MONTGOMERY COUNTY HISTORIC PRESERVATION COMMISSION
STAFF REPORT

Address:	29 West Kirke Street, Chevy Chase	Meeting Date:	5/21/2019
Resource:	Outstanding Resource Chevy Chase Village Historic District	Report Date:	5/14/2019
Applicant:	Katy & Bryan Anderson (Chris Snowber, Architect)	Public Notice:	5/7/2019
Review:	HAWP	Tax Credit:	N/A
		Staff:	Michael Kyne

Case Number: 35/13-19Q

PROPOSAL: Screened-in porch alterations and new construction

Fig. 2: Previously proposed west elevation (left) and current proposal (right).

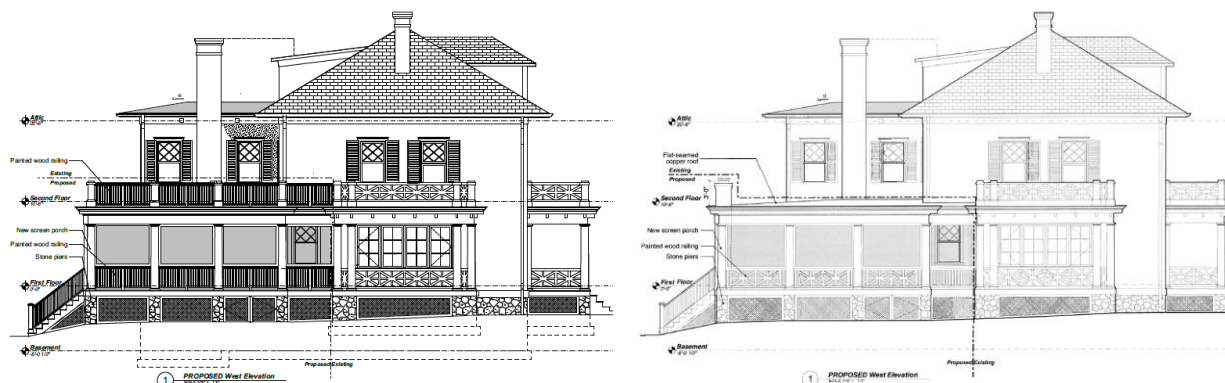
At the preliminary consultation, the HPC found that the proposed new railings with balusters would introduce a new feature to such a large degree that it could detract from the integrity and character of the historic house. This would be inconsistent with the *Guidelines* and with *Standard #2*, which states that the historic character should be preserved.

The HPC recommended that the applicants revise their proposal for the new screened porch, with the proposed railings taking more design cues from the historic house. The applicants have returned with a new application, proposing to match the style of the new railings to the existing railings on the historic house. Screens will be installed behind the proposed railings for code compliance, and there will be a 2' deep x 5'-5" long inset between the existing and proposed screened porch for differentiation. There will be a 5'-5" long section of traditional wood railings with balusters for the length of the inset. The roof of the proposed screened porch will be a low-sloped flat-seamed copper roof. There will be stairs to grade with traditional wood railings at the rear of the proposed screened porch.

Staff finds that the applicants have responded to the Commission's previous concerns. As revised, the proposed new screened porch takes design cues from existing features on the historic house. Traditional railings are still proposed for the rear stairs to grade, but the Commission did not express concerns about the railings in this location. Although a small section of traditional railing is still proposed between the existing and proposed screened porch, it will be inset 2', making it less visible from the public right-of-way. Additionally, the railing is proposed in limited amounts, mitigating previous concerns about the cumulative effect of the new railings.
